HORSHAM DISTRICT COUNCIL CONSULTATION

TO:	Horsham District Council – Planning Dept
LOCATION:	Land at Sumners Ponds Chapel Road Barns Green West Sussex
DESCRIPTION:	Application for Approval of Details Reserved by Conditions 18 and 19 to approved application DC/21/2697
REFERENCE:	DISC/25/0395
RE-CONSULT:	1 st set of comments in black 2 nd set of comments in blue
RECOMMENDATION:	Holding Objection / More Information / Modification Advice

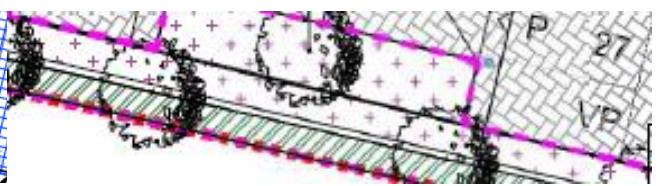
- i. Details of all existing trees and planting to be retained
 - a. *No concerns raised.*
- ii. Details of all proposed trees and planting, including schedules specifying species, planting size, densities and plant numbers and tree pit details
 - a. *The landscaping proposals have been coordinated with the attenuation tank locations, with thanks, however they remain uncoordinated with the drainage strategy. We note various conflicts with drainage runs, therefore we request the strategies are coordinated and that trees are re-located to ensure they can be delivered. Please see examples highlighted below.*

Not addressed in full. Please note that the below screenshots are examples and are not exhaustive. Further conflicts remain, such as the tree proposed between the parking spaces of plots 12 and 13. Please coordinate the landscape and drainage strategy in order to fully demonstrate potential conflicts with drainage runs.

This tree has not been altered.

This tree has not been altered.

This tree has been altered, with thanks. Closed.

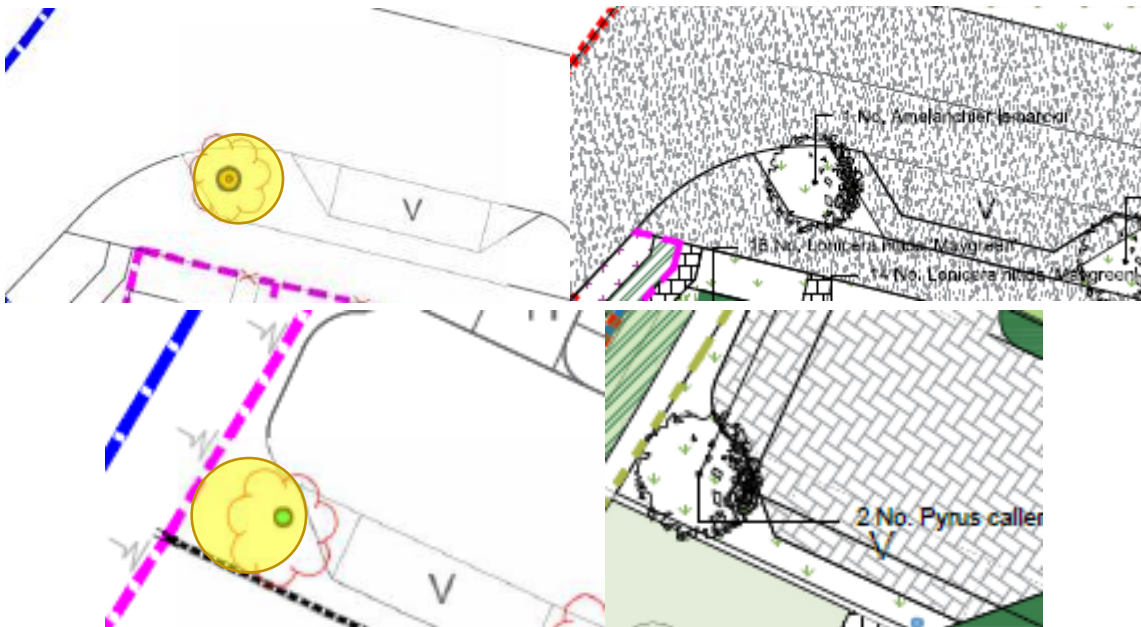
- b. As above, the landscape strategy must also be coordinated with the lighting strategy, ensuring that utility runs are indicated in addition to fixtures to ensure no further conflicts. Current areas of proximity and/or potential conflict are highlighted below and modification is thus requested.

Minor alterations have been made. While the locations remain in proximity, we are confident that the trees can be secured. Closed.

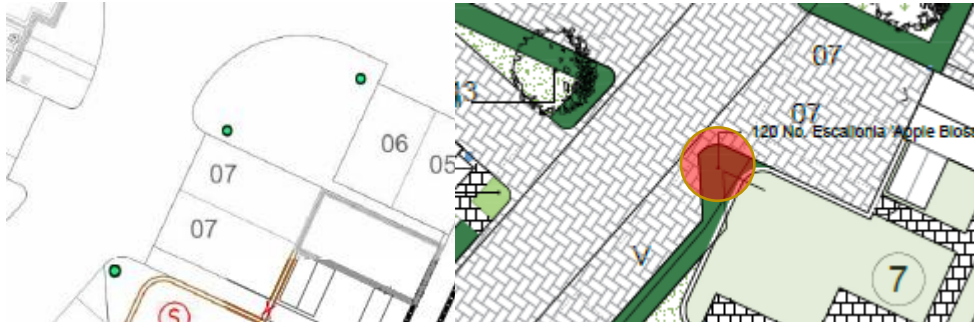
- c. Please reinstate tree adjacent to plot 7, highlighted in red below.

Closed, with thanks.

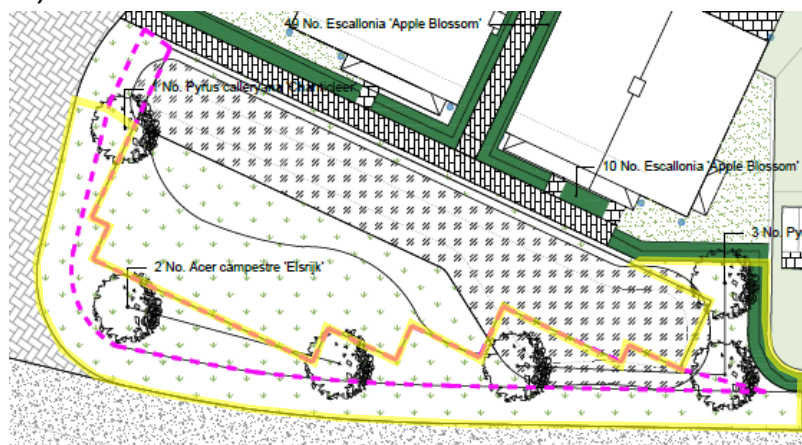
- d. Further to tree planting conflicts, concerns remain in regard to root barrier locations. While some locations have been included, with thanks, there remain various locations where they are required. In addition, drainage runs have not been factored in and thus we are not confident that all trees can be successfully delivered and established. Please review.

- e. As above, please amend the root barrier within the central green to avoid drainage runs and to align with the road to increase available rooting medium. See suggestion below in yellow.

As per ii.a, plans have still not been coordinated to demonstrate no conflict. However, we note the applicant's response dated 14.01.26 stating, "Sigma Homes will closely oversee these works and adjust and add runs of barriers if necessary due to underground conditions as we progress the install". Closed.

Services route noted, closed.

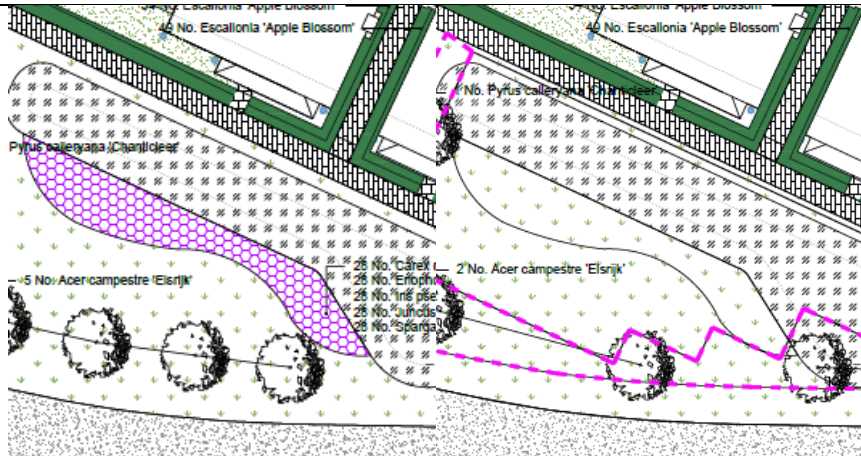
- f. Please reinstate marginal planting mix as reflected in previous proposals. [DISC/25/0116 below left, current application below right]

Closed, with thanks.
